Permit No. 17-132430

DEWBERRY 2E
COMPLIANCE PACKAGE 'A4'

Greenpark.
 Project name
 RUSSELL GARDENS PH.2
 Municipality
 WATERDOWN, ON.
 Date
 JUNE 2017
 Drawn by
 WT
 checked by
 3/16" = 1'-0"
 scale
 TYPICAL NOTES & AREAS
 16036-DEWBERRY-2E
 JUL 6 2018 - 4:03 PM

BASEMENT PLAN ELEVATION '1'

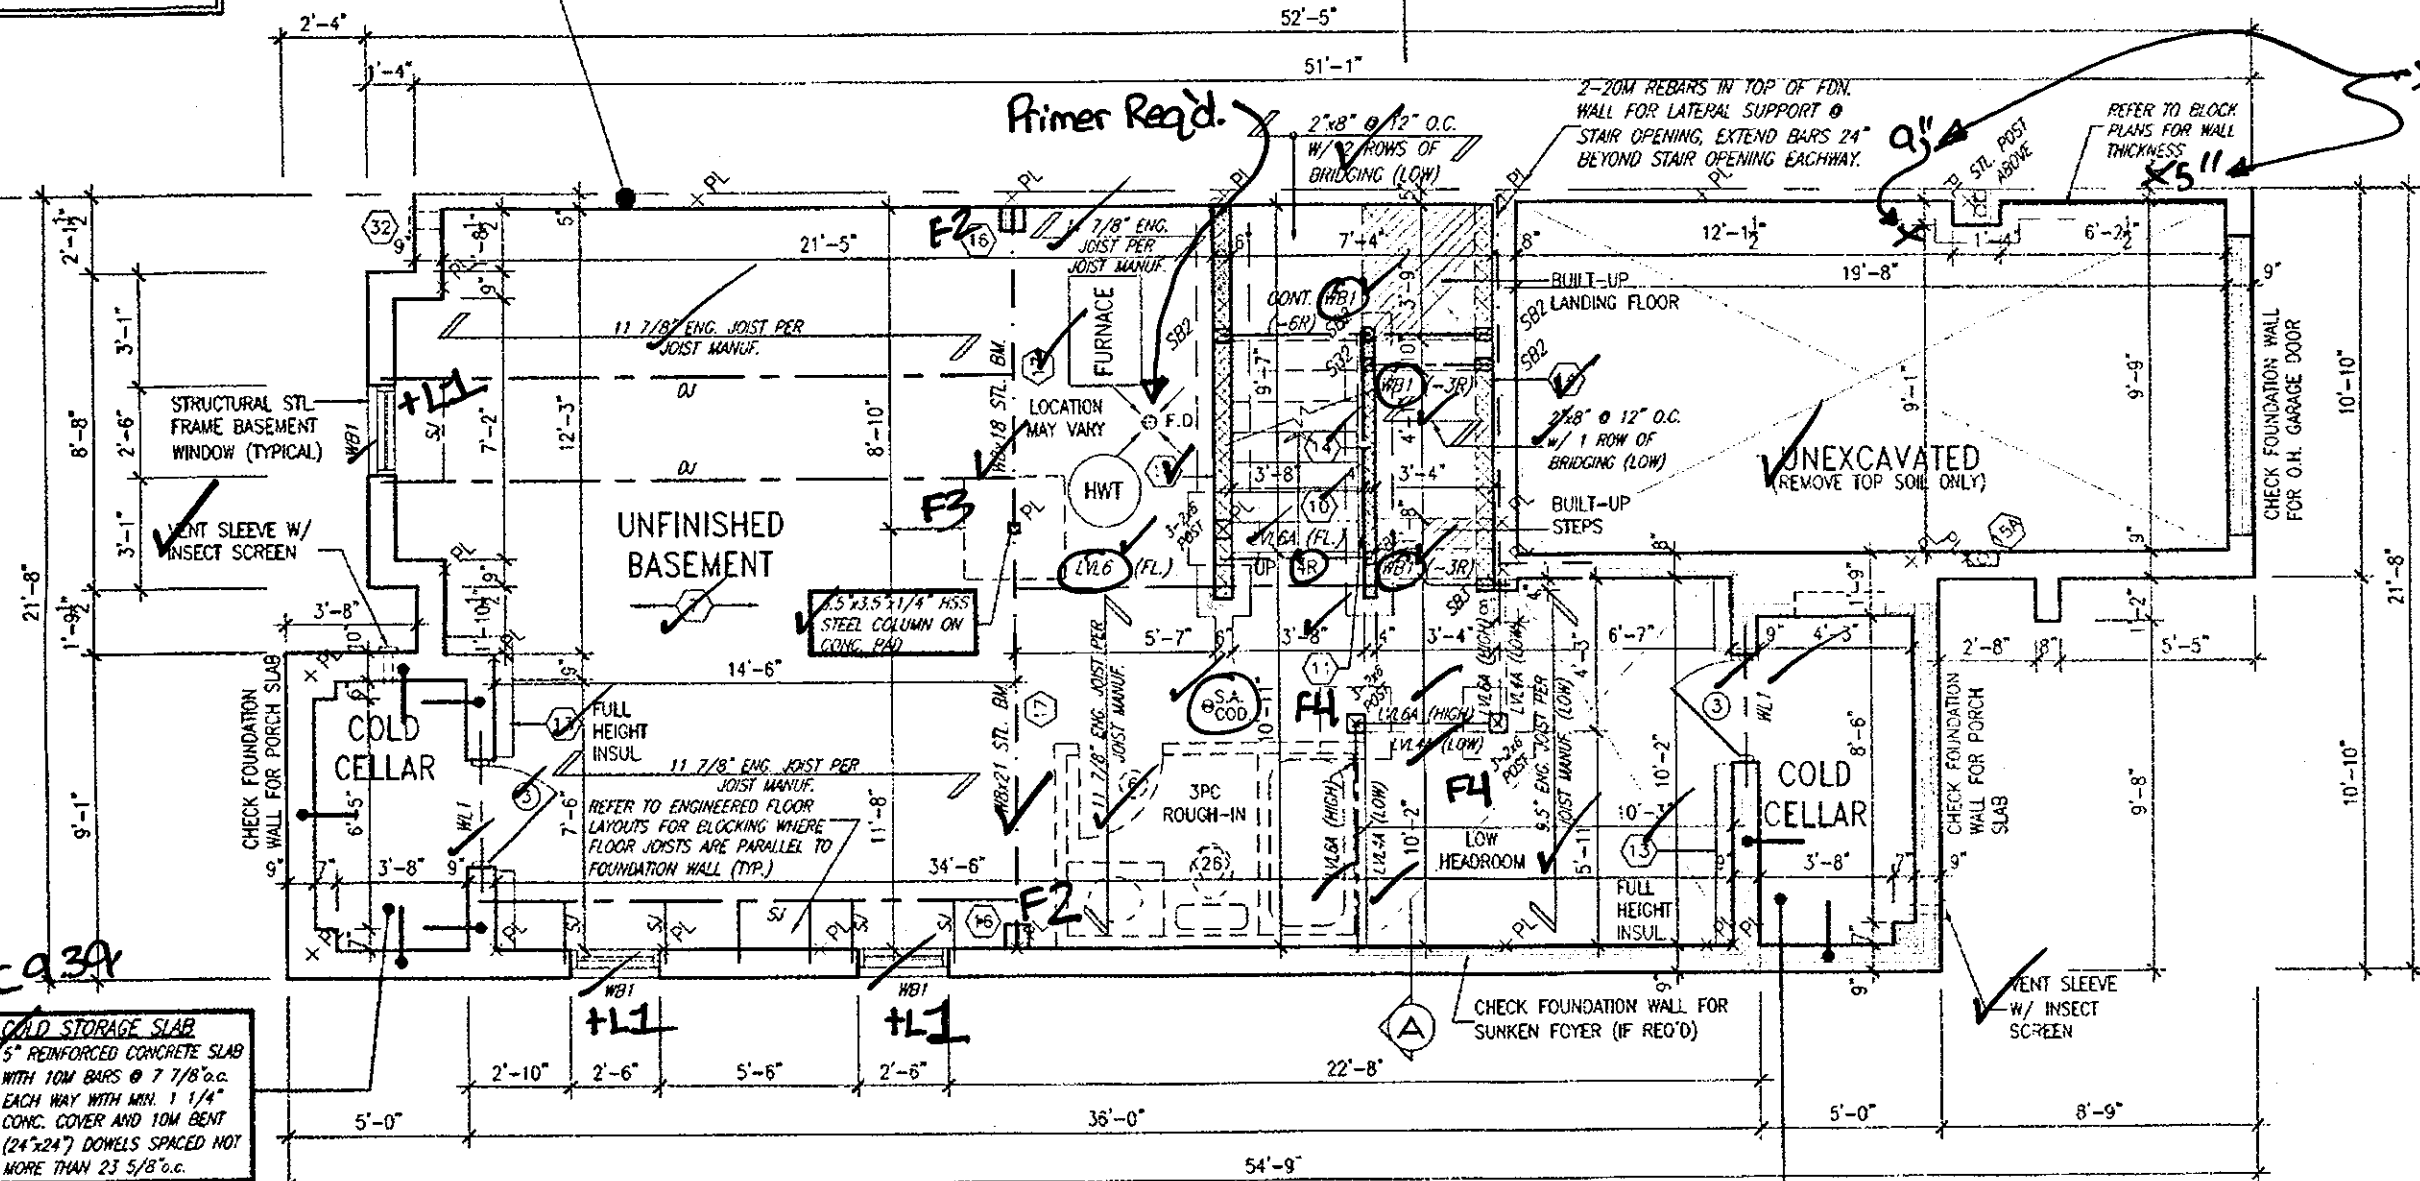
**As per updated details on page 12B*

ENTRY LEVEL PLAN ELEVATION '1'

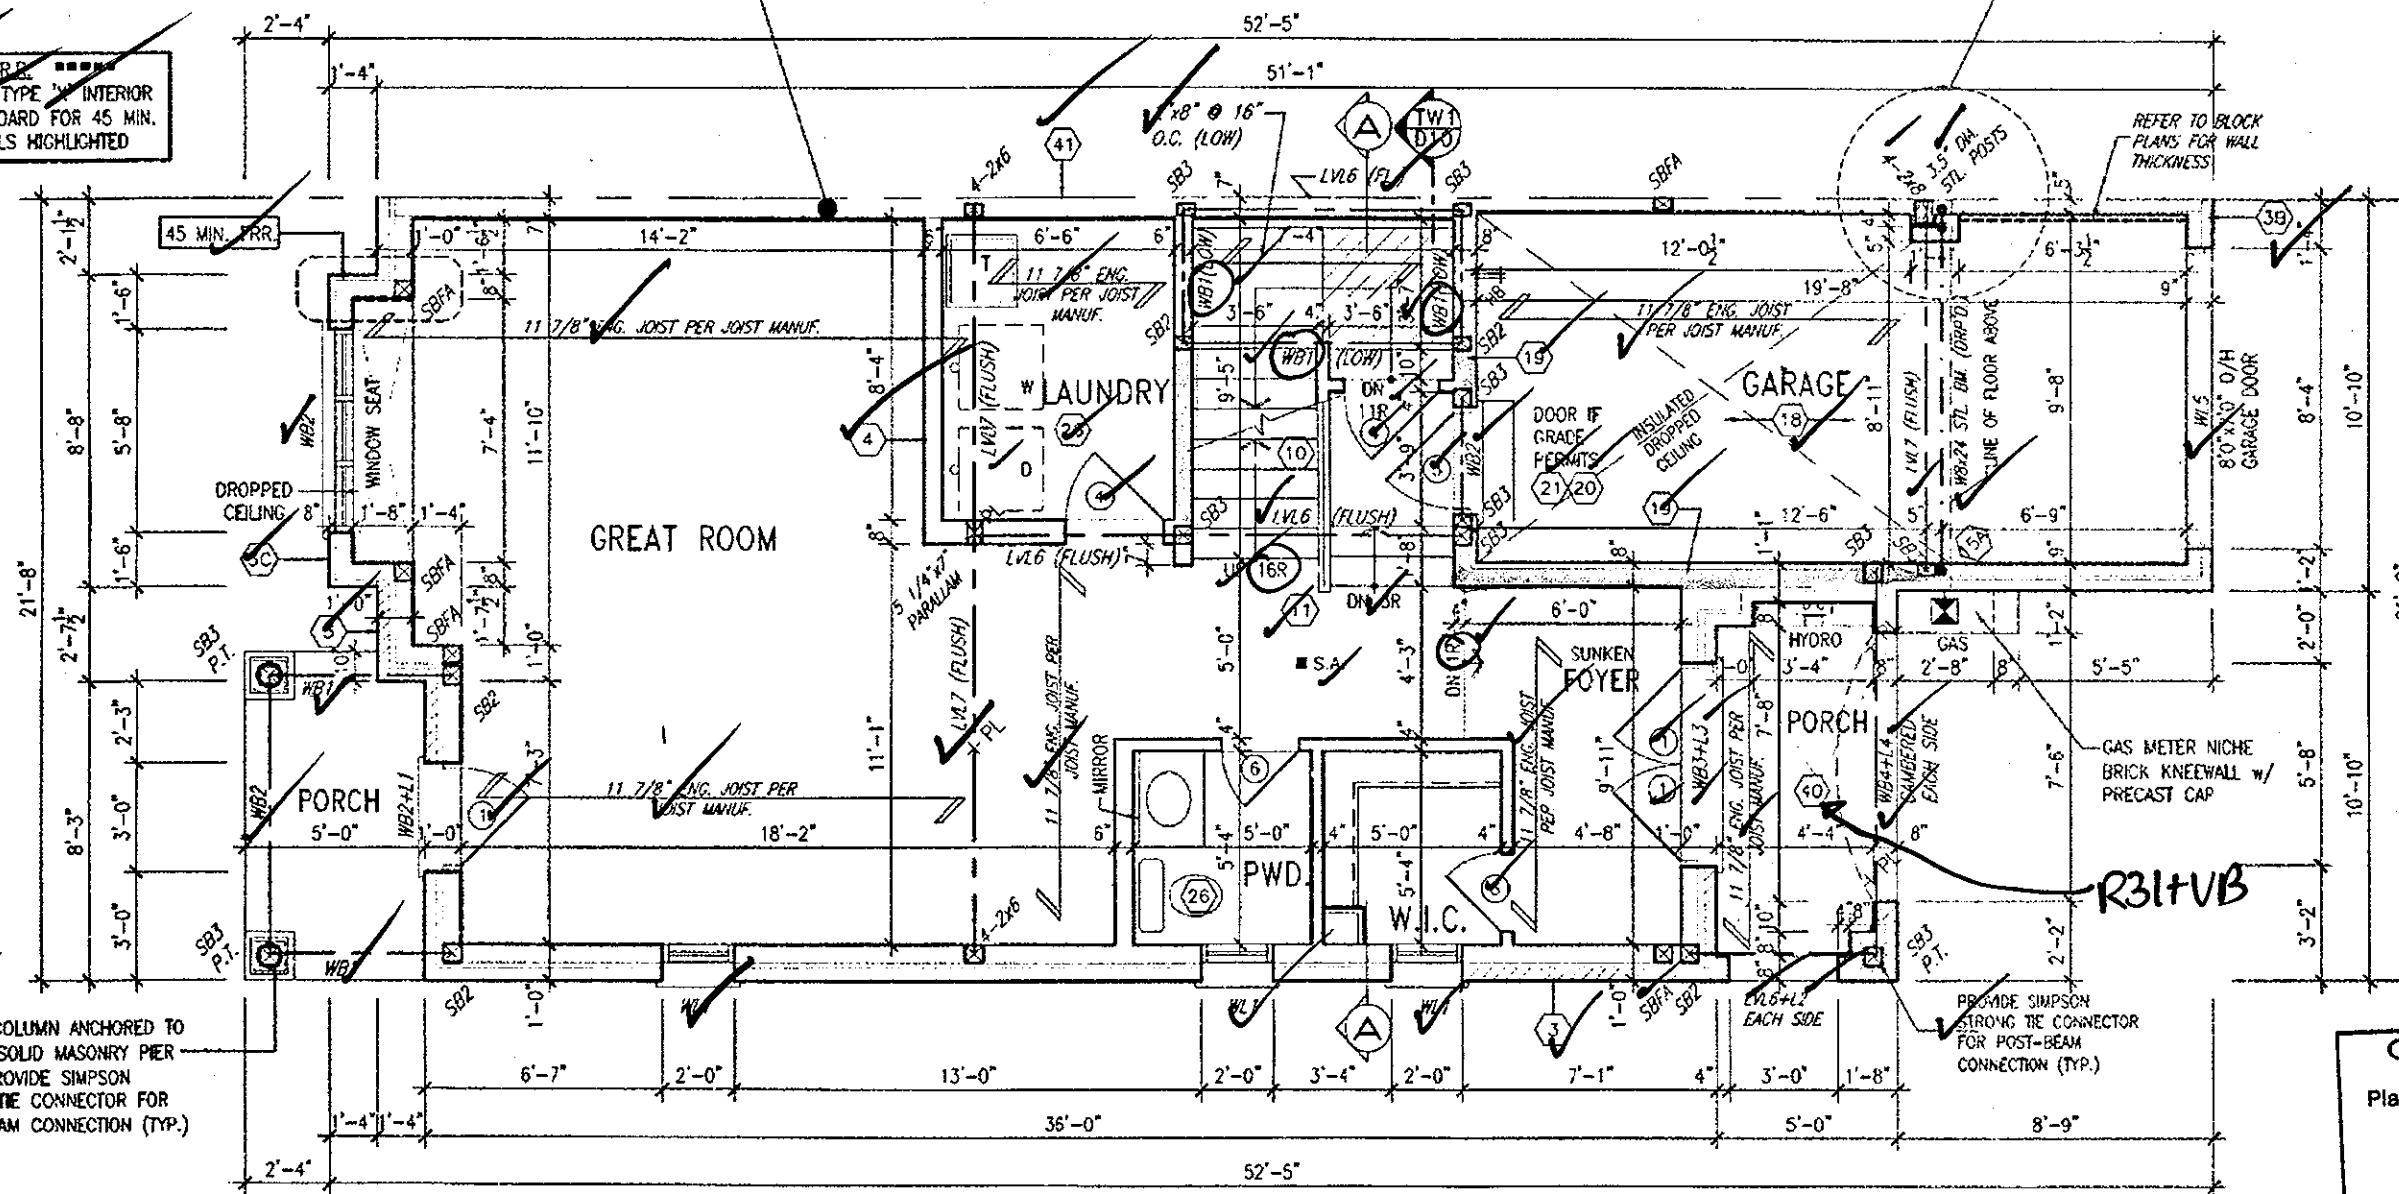
45 MIN. F.R.R. **USE 5/8" TYPE "X" INTERIOR
GYPSUM BOARD FOR 45 MIN.
F.R.R. WALLS HIGHLIGHTED**
